SIB 34 02 24

RECALL 24V-104: INTEGRATED BRAKING SYSTEM

This Service Information Bulletin (Revision 9) replaces SI B34 02 24 **dated February 2025**.

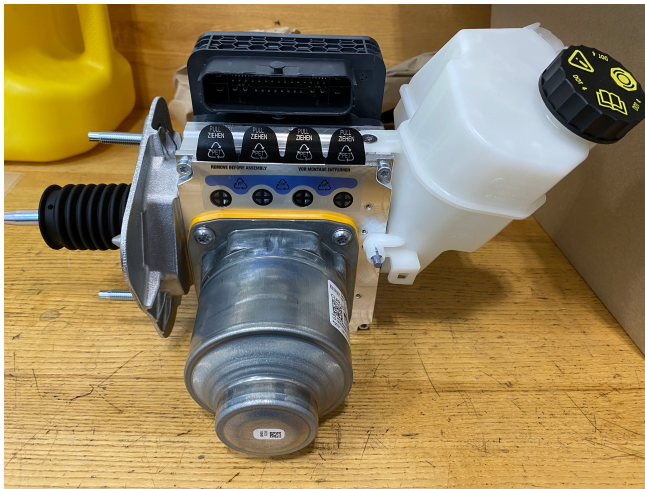
Replace the IB with either a “wet” pre-filled unit or a “dry” unfilled unit.

“Wet” IB pre-filled: Brake fluid reservoir is filled (arrow) and brake fluid line ports are plugged with bolts (circled).

Part numbers:

5B67B85
5B6E463
5B6E467
5B69D65
5B69D61
5B69D63
5B72715
5B72716
5B6F947

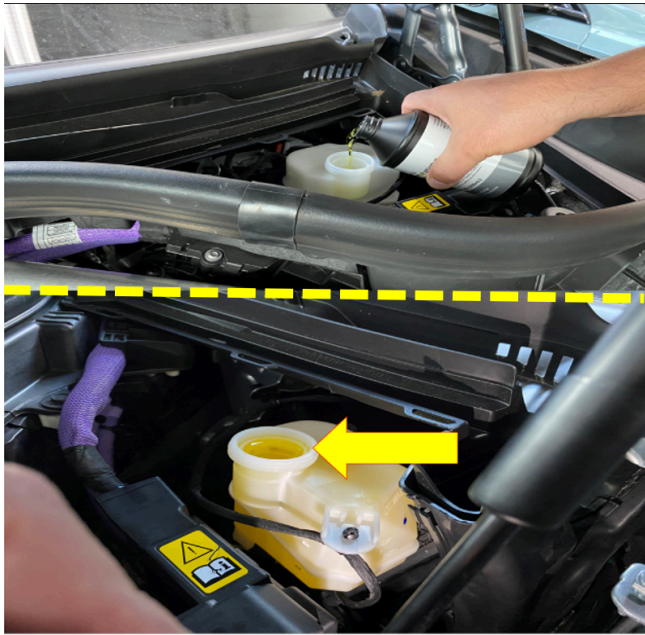
“Dry” IB unfilled: Brake fluid reservoir is empty; brake fluid line ports are sealed with labels.

Note: Additional work is necessary to install these “Dry” units. Refer to the Claim Information section.

Part numbers:

5B3C874
5B3C857
5B421D0
5B3C859
5B6C7F2
5B6C7F3
5B6C7F5
